UNITED STATES
NUCLEAR REGULATORY COMMISSION
WASHINGTON, D. C. 20555

SURRY POWER STATION, UNIT NO. 1

Amendment No. 44
License No. DPR-32

Amendment No. 43
License No. DPR-37

TS 3.1-7
TS 6.4-7a
TS 6.4-7b
TS 3.16-2
TS Fig 6.1-3

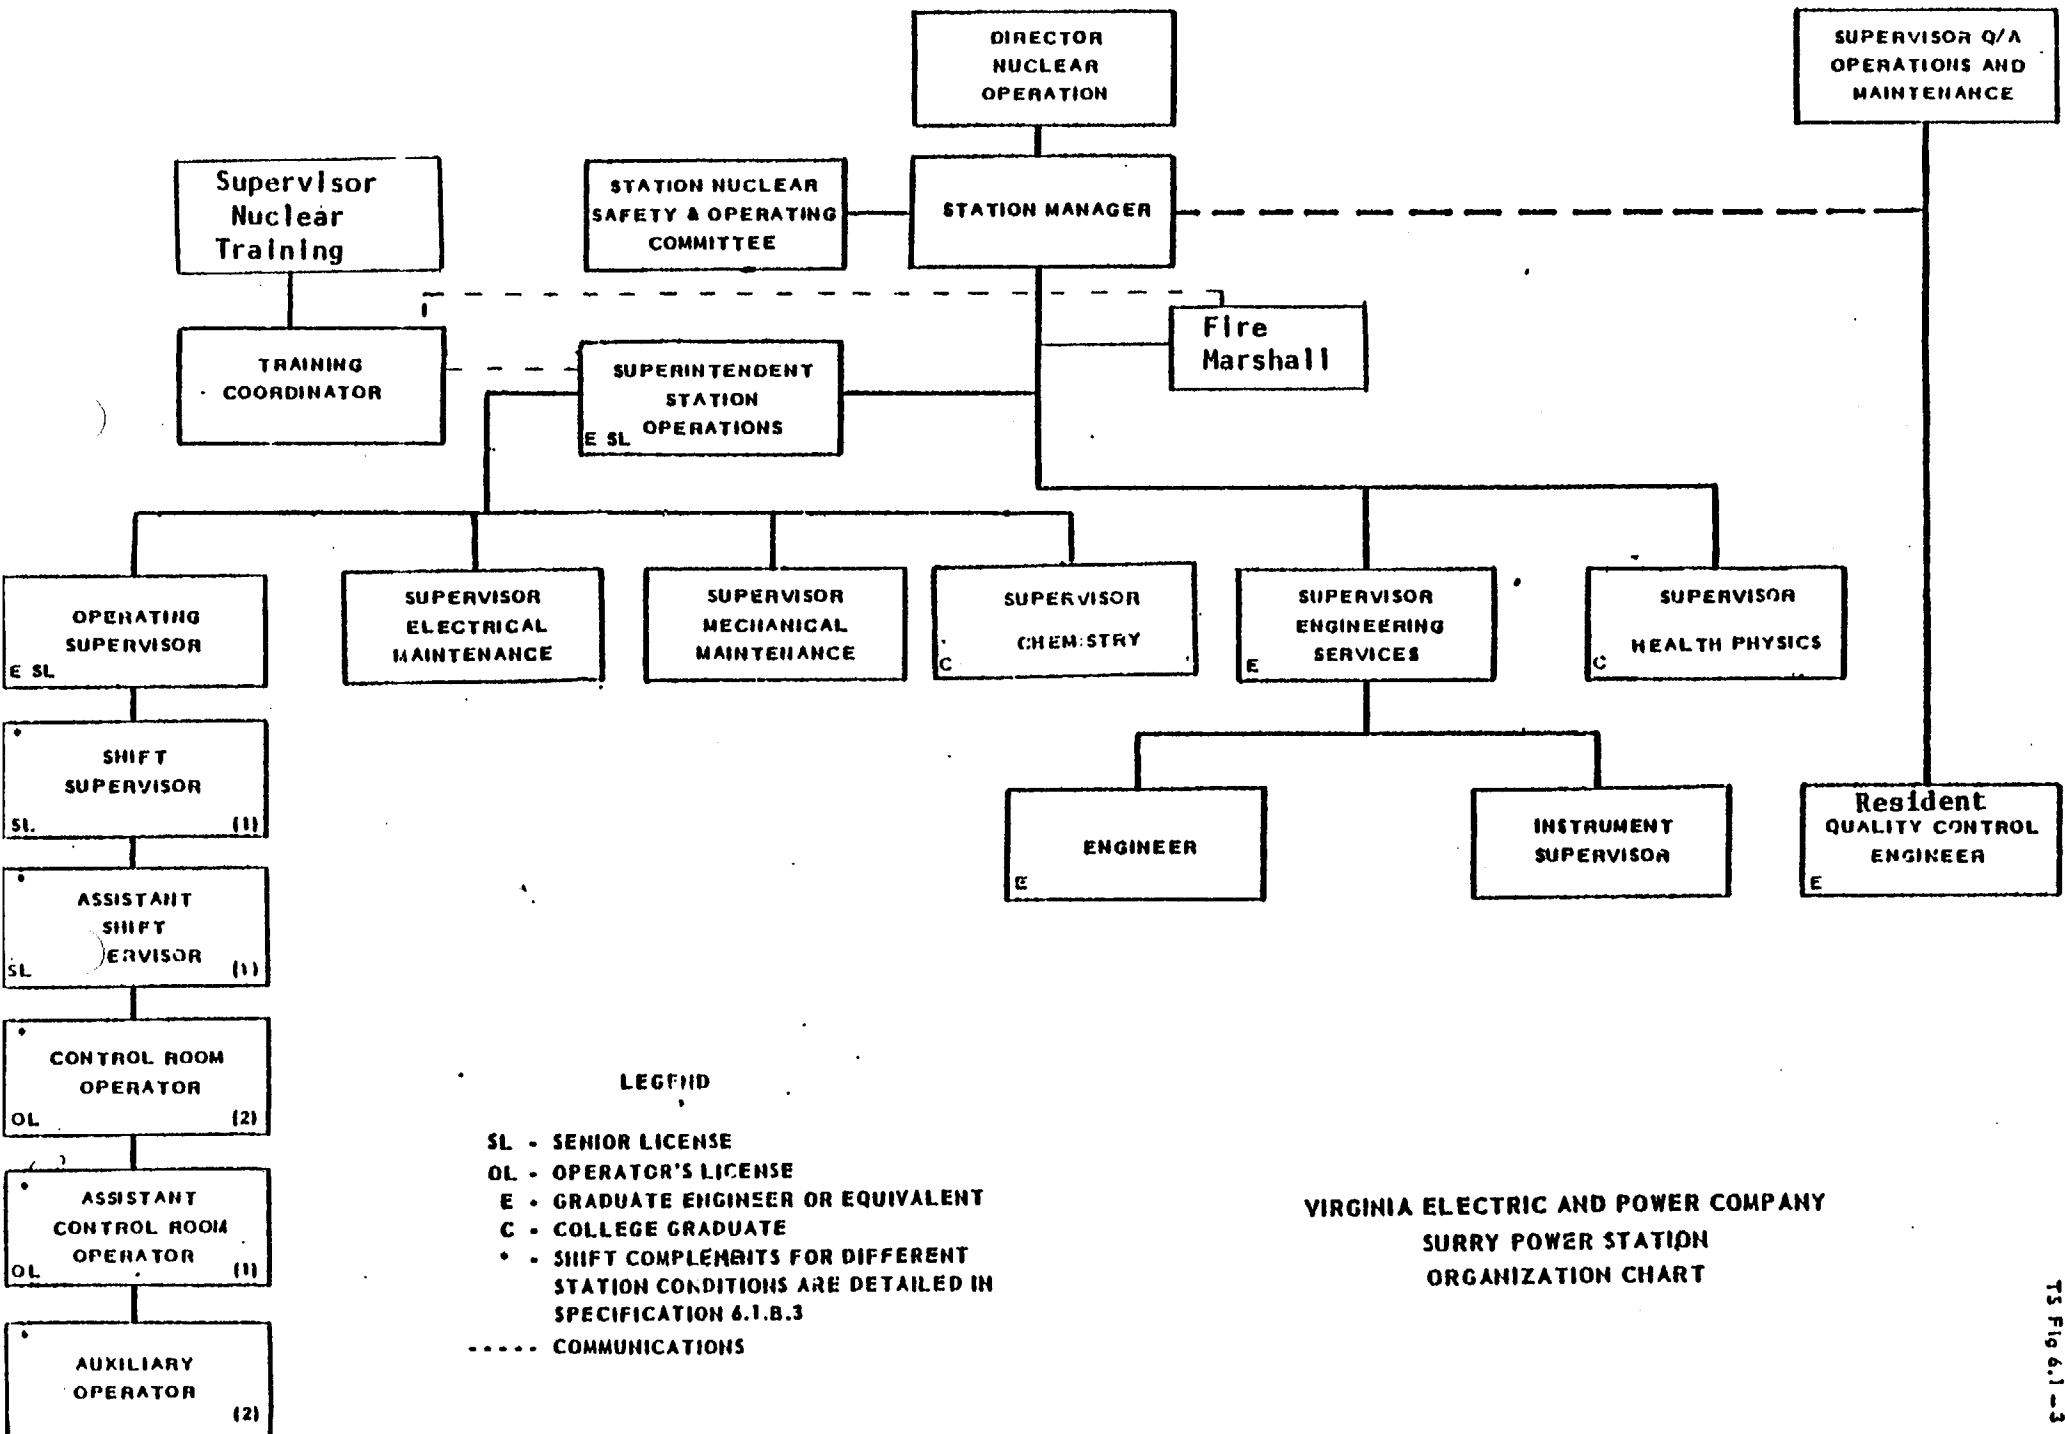
These changes to the Technical Specifications, (1) reduce the allowable pressurizer heatup rate from 200°F/hr to 100°F/hr, (2) reflect a new title of "Resident Quality Control Engineer" to replace "Quality Control Engineer," and (3) correct a typographical error on page TS 3.16-2 which was issued on May 10, 1978.

These changes to the Technical Specifications, (1) reduce the allowable pressurizer heatup rate from 200°F/hr to 100°F/hr, (2) reflect a new title of "Resident Quality Control Engineer" to replace "Quality Control Engineer," and (3) correct a typographical error on page TS 3.16-2 which was issued on May 10, 1978.
